VESSEL'S NAME Iron S.S. Dunmail Rpt. By No. 9874

2nd S.S. No. 3.

THICKNESSES OF PLATING ascertained by drilling, and comparison of same with the original thicknesses.

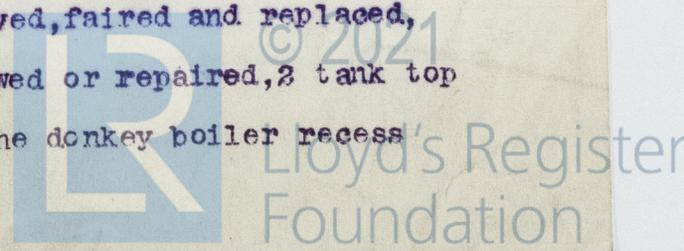
The 2nd S.S.No.3 has now been held and the plating drilled as shewn above with results which it is submitted may be considered satisfactory.
